**NOTICE OF PUBLIC HEARING**  
**Minor Variance**

<b>APPLICATION NO.:</b>	<b>AN/A-22:180</b>	<b>SUBJECT PROPERTY:</b>	64 LOVERS LANE, ANCASTER, Ontario
<b>ZONE:</b>	"ER" (Existing Residential)	<b>ZONING BY-LAW:</b>	Zoning By-law former Town of Ancaster 87-57, as Amended 18-105

**Re: 64 Lovers Lane, Hamilton**  
**Minor Variance Application Resubmission – AN/A-22:180**

**PROPOSED  
SITE PLAN  
3/32"=1'-0"**

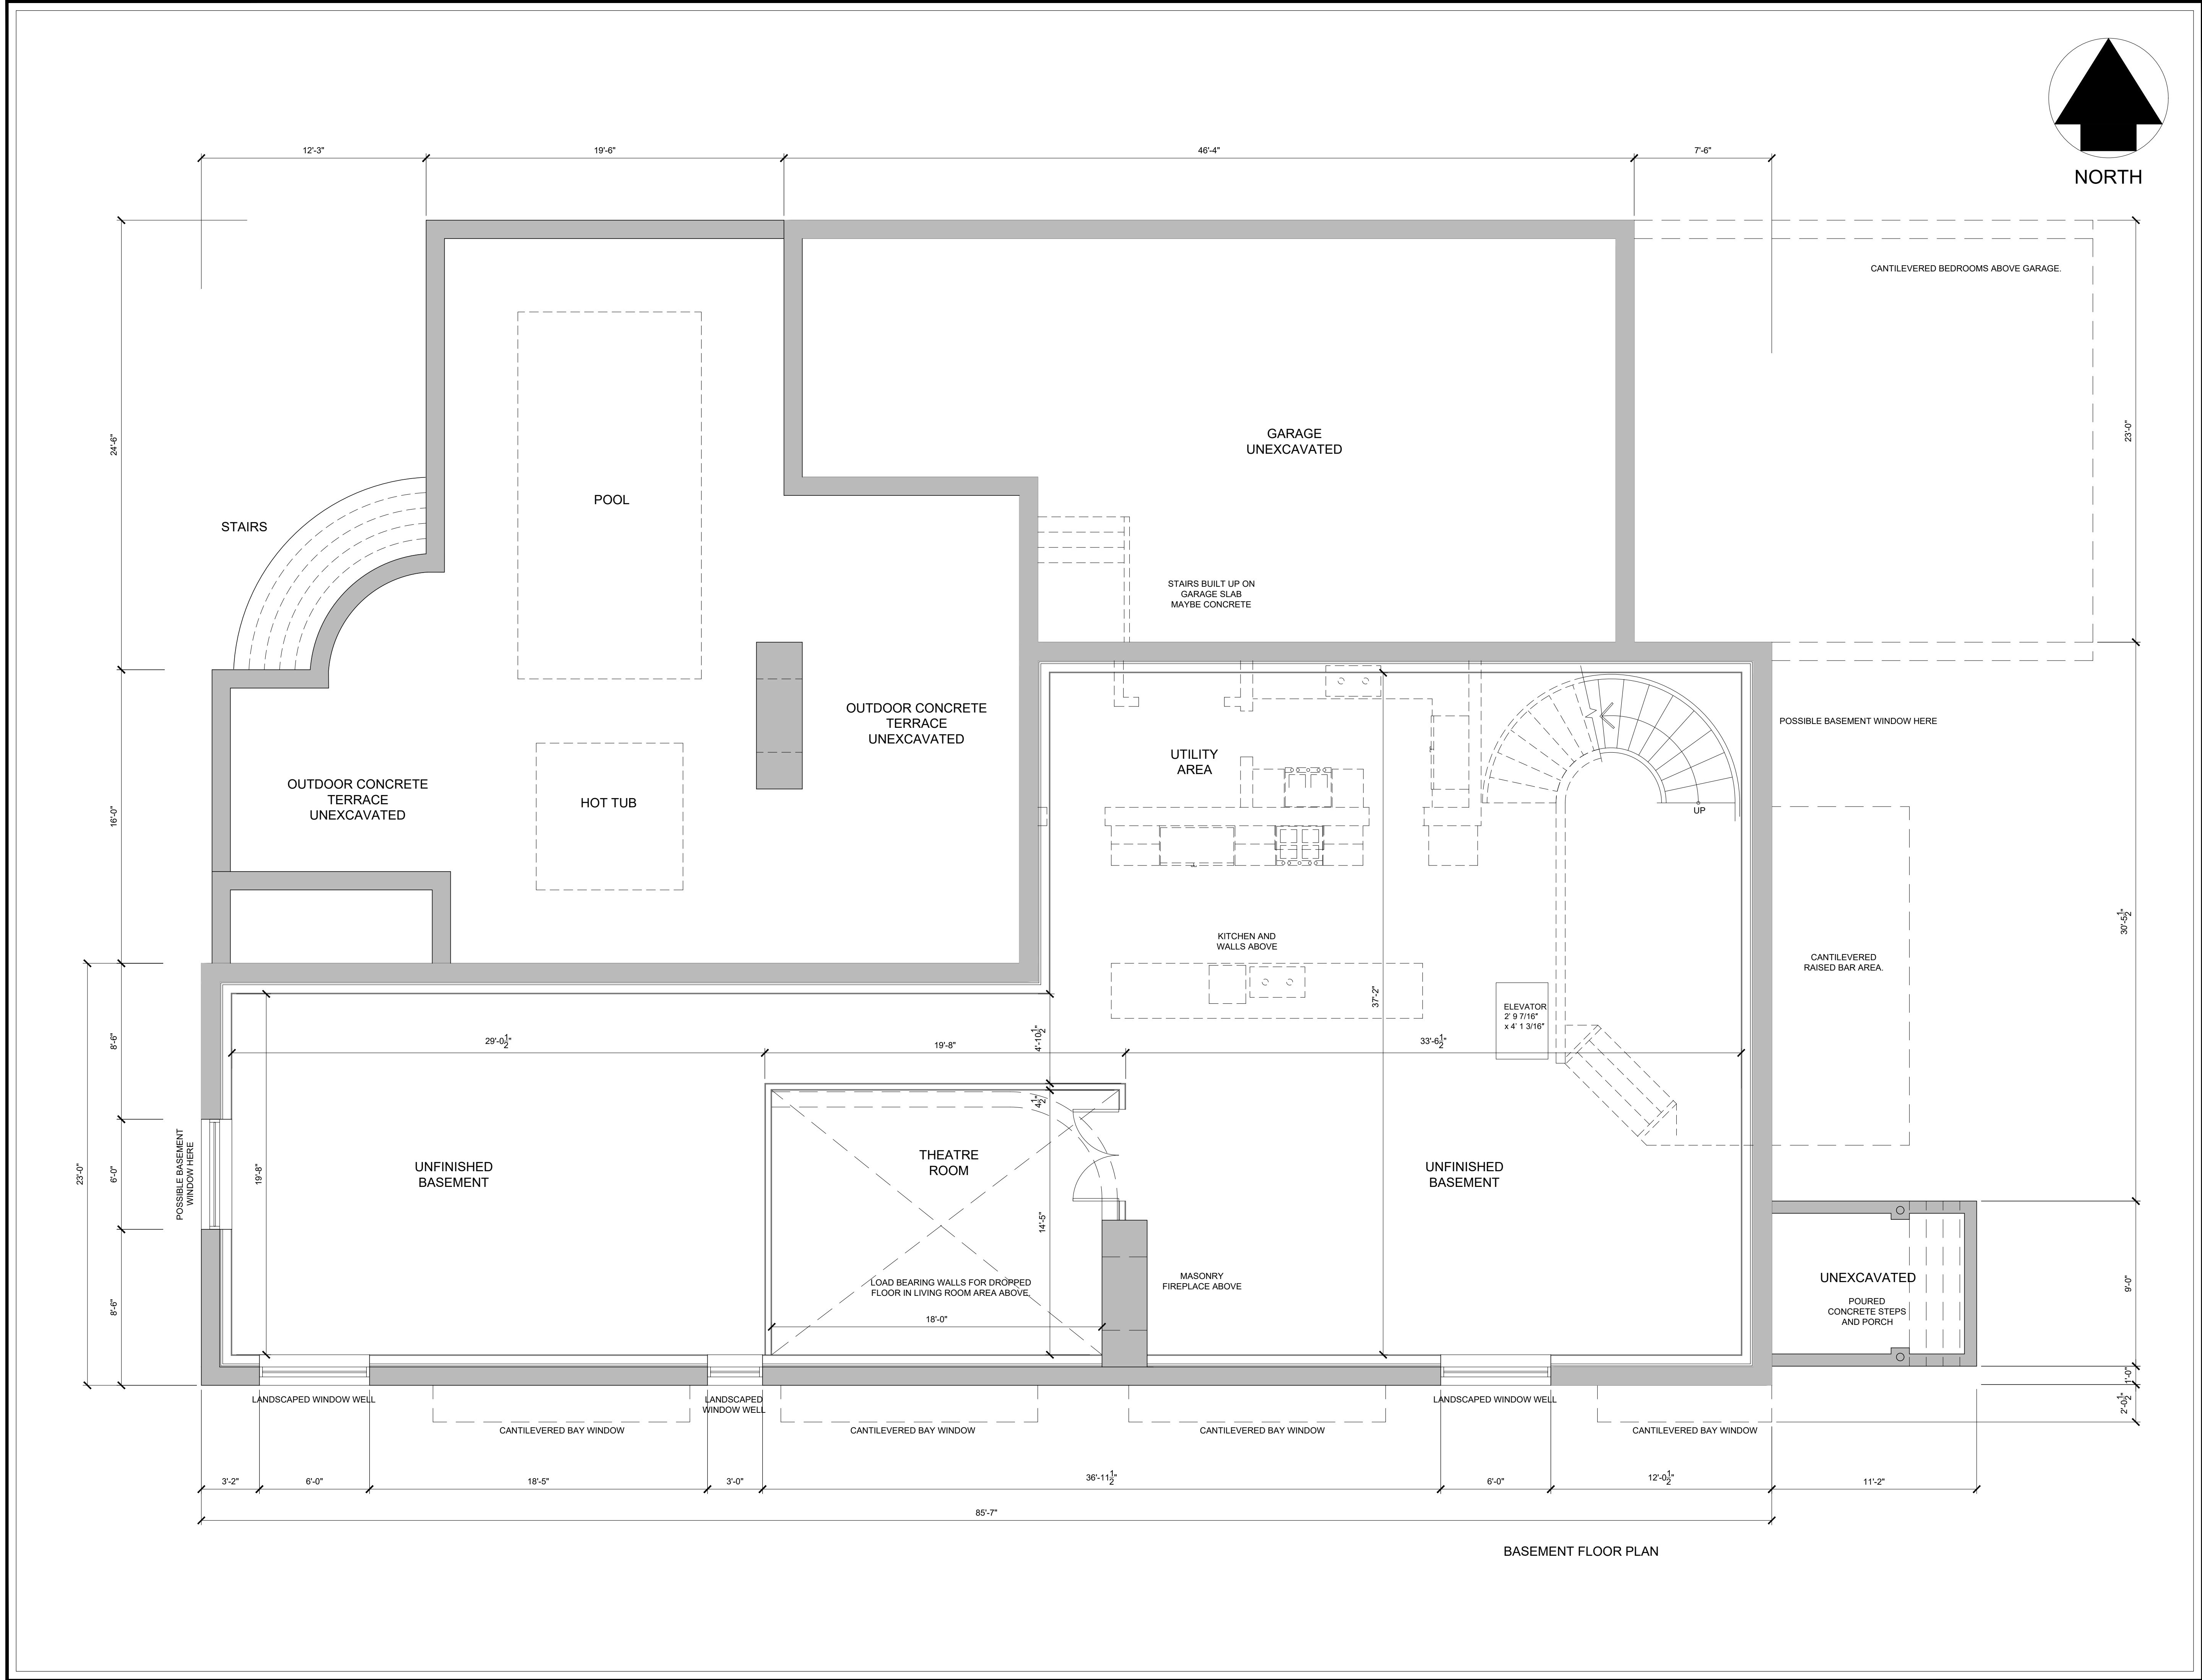
1. Please note that the Site Plan statistics indicate a total proposed lot coverage of 38 percent, whereas a maximum lot coverage of 35 percent is permitted. It is noted that the area of all buildings is indicated as 473.34 square metres, which is 37.72 percent of the area of the lot (i.e. lot area indicated as

1254.84 square metres). As such, a variance has been added to address this. Should the lot coverage be more than 37.80 percent, an additional variance may be required.

2. Specific details regarding the bay windows of the proposed single-family dwelling were not indicated on the submitted site plan. Please note as per a Divisional interpretation for Bay Windows, the proposed bay windows do not meet the form and intent of a bay window as it does not meet the following criteria:
  - a) A bay window is a window first and foremost
  - b) A bay window is a projection of the window from the building wall
  - c) A bay window may have a foundation to assist in the support of the window
  - d) A bay window cannot be a wall or similar feature such as an alcove or other extension of a room and its floor area

4. Specific details regarding the projection of eaves/gutters of the proposed single-family dwelling were not indicated on the submitted site plan. Please note that should the variance requested to permit a reduced minimum front, side and rear yard setback be approved, as per Section 7.12(b), eaves and gutters shall be permitted to project into the new minimum side yard a distance of not more than 0.60 metres, or into the minimum front yard and rear yard a distance of not more than 1.5 metres. Additional variances may be required if compliance with Section 7.12(b) is not possible.

7. Please note that should the variance requested to permit a reduced minimum rear yard setback, the proposed accessory structure (in-ground pool) will not be located in a required rear yard and will therefore comply with Section 7.18(a)(vi). However, the distance from the proposed in-ground pool

to the rear lot line has not been indicated. As per Section 7.18(a)(vi)(A), accessory buildings in excess of 12 square metres ground floor area shall not be less than 7.5 metres from the rear lot line for any lot located in an Existing Residential “ER” Zone. Additional variances may be required if compliance with Section 7.18(a)(vi)(A) is not possible.
